**Interdisciplinary Science Building
Webster University
Cannon Design Project No. 004561.01**

Project: Webster ISB Substitution Request Number: 22
From: Joe Voypick
To: Kelvin Patel Date: 06/08/16
Re: _____ Contract For: _____

Specification Title: Acoustical Panel Ceilings Description: _____
Section: 095113 Page: A0701.B Article/Paragraph: Ceiling Legend

Project: Webster ISB Substitution Request Number: 19
From: DOUG MAYHEW
To: KELVIN PATEL Date: 05/13/16
Re: _____ Contract For: _____

Isolation Hangers Model AF

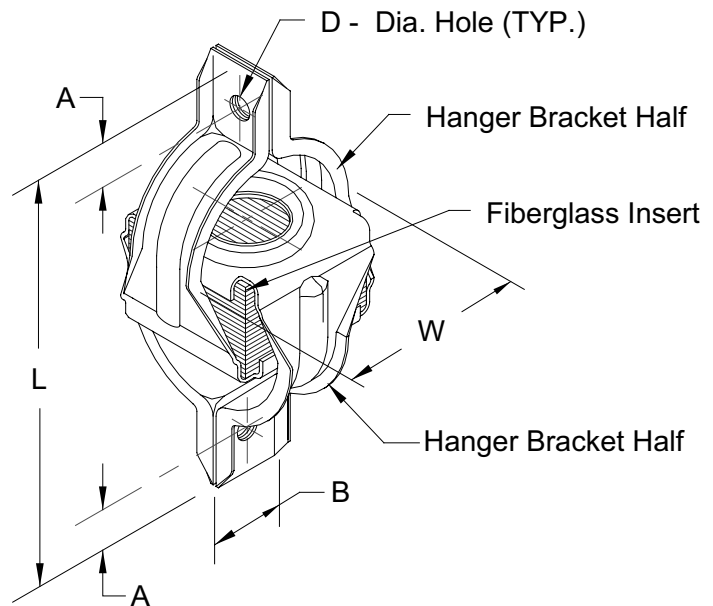
APC-9: Ceiling Tile appearance acceptable; Verify that acoustical backing & hangers per specification will be provided. Grid rejected - 1/8" Bolt slot required.

QuietTile Acoustical Ceiling System

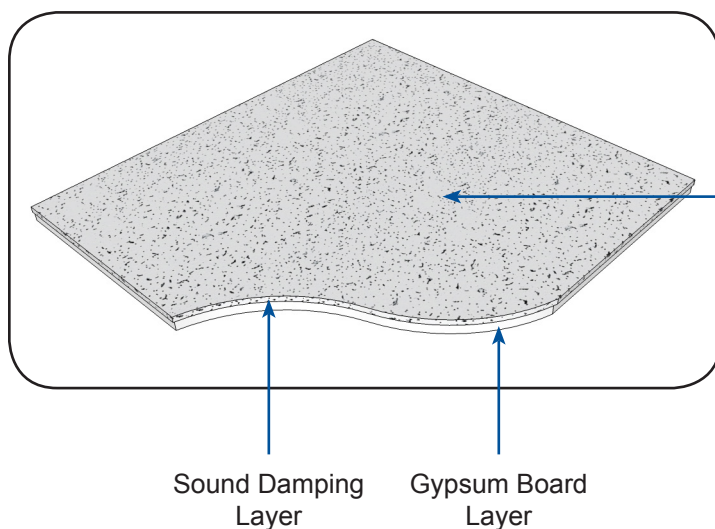
Comments: NOTE: FOR APC-9: TILE USED WITH QUIET TILE BACKER TO BE APC-7.

TILE TO BE APC-7
